Eastridge to BART Regional Connector

Final Second Supplemental
Environmental Impact Report
Volume I: Revised Draft SEIR-2 and
Response to Comments

Eastridge to BART Regional Connector: Capitol Expressway Light Rail Project

State Clearinghouse #2001092014

Figure 2-1
Proposed Changes to Capitol Expressway Light Rail Project

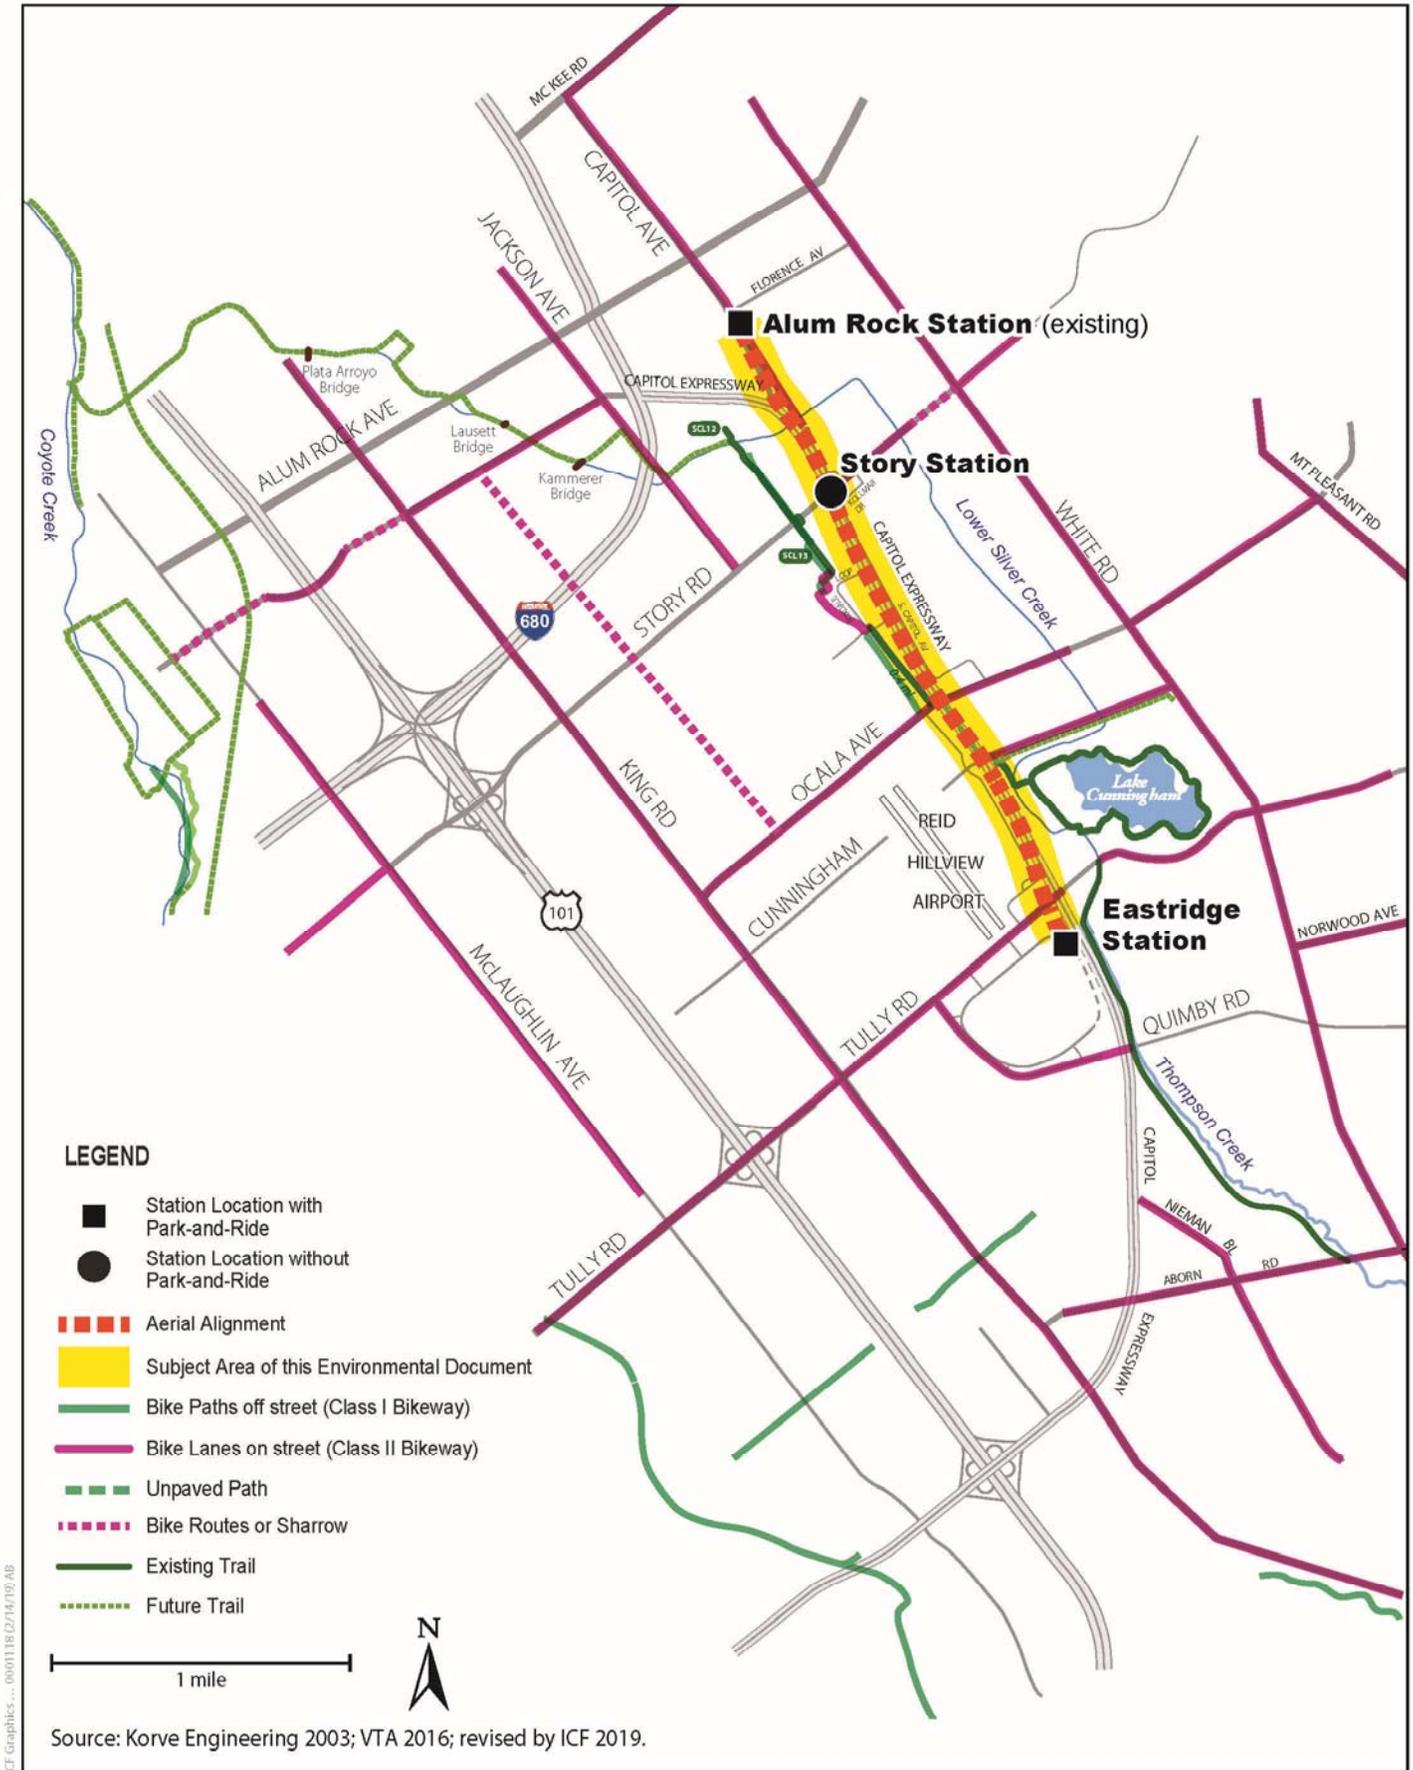
- L1-22 The comment requests that VTA revise bikeways represented on maps to accurately reflect current conditions. The bikeways shown in Figures 2-1 and 3-1 in the Draft SEIR-2 as well as Figures 1-1 and 2-1 from the Second Subsequent Initial Study (included in Attachment G in Volume III of the Draft SEIR-2) have been revised per the City’s comments. These figure changes are documented in Chapter 4, *Major Revisions to the Draft Second Supplemental Environmental Impact Report*.

Figure 2-1 has been revised as shown on the following page.
